Proposal for amendments to GRPE-76-26r1e

The text reproduced below was prepared by the IWG on Worldwide harmonized Light vehicles Test Procedure (WLTP). The modifications to the current text of GRPE-76-26r1e are marked in bold for new or struck through for deletion.

Annex 2, paragraph 4.(b), amend to read:

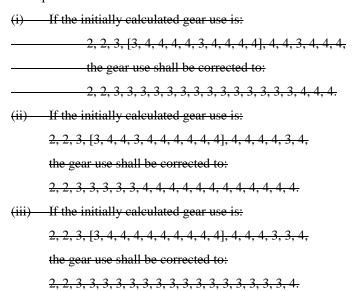
"If a downshift is required during an acceleration phase, the gear which is required during this downshift is shall be noted (i_{DS}) . The starting point of a correction procedure is defined by either the last previous second when i_{DS} was identified or by the starting point of the acceleration phase if all time samples before have gears $> i_{DS}$. The last previous second where i_{DS} shall be identified and defines the start point of a correction procedure. The highest gear of the time samples before the downshift determines the reference gear i_{ref} for the downshift. A downshift where $i_{DS} = i_{ref} - 1$ is referred to as a one step downshift, a downshift where $i_{DS} = i_{ref} - 2$ is referred to as a two step downshift. The following check shall then be applied.

Working backwards forward from the starting point of the correction procedure to the end of the acceleration phase, the latest occurrence of a 10 second window containing iDS for either 2 or more consecutive seconds, or 2 or more individual seconds, shall be identified. The last usage of i_{DS} in this window defines the end point of the correction procedure. Between the start and end of the correction period, all requirements for gears greater than iDS shall be corrected to a requirement of i_{DS} .

If one step downshifts as well as two step downshifts occur during an acceleration phase, two step downshifts shall be corrected before one step downshifts are corrected. In this case, the starting point of the correction procedure for the one step downshifts is the second immediately following the end of the correction period for the

two step downshifts. If a two step downshift occurs after a one step downshift, it shall overrule the one step downshift in the time period before the two step downshift.

From the end of the correction period (in case of 10 second windows containing i_{DS} for either 2 or more consecutive seconds, or 2 or more individual seconds) or from the starting point of the correction procedure (in case all 10 second windows contain i_{DS} only for one second or some 10 second windows contain no i_{DS} at all) to the end of the acceleration phase, if the downshift was a one step downshift, all downshifts with a duration of only one second shall be removed., if the downshift was a one step downshift. If the downshift was a two step downshift, all requirements for gears greater than or equal to i_{DS} up to the latest occurrence of i_{DS} shall be corrected to ($i_{DS}+1$).

This final correction shall also be applied from the start point to the end of the acceleration phase, if no 10 second window containing iDS for either 2 or more consecutive seconds or 2 or more individual seconds was identified.

Correction/justification: A downshift by more than 1 gear could occur at the transition from a deceleration or constant speed phase to the acceleration phase. In these cases, the necessary computer program, ACCESS, replaces the gear for the last sample of the deceleration or constant speed phase by gear 0 and sets the clutch "disengaged". Some text is also required for reasons of clarity. Agreed by experts at IWG #22, Ispra.
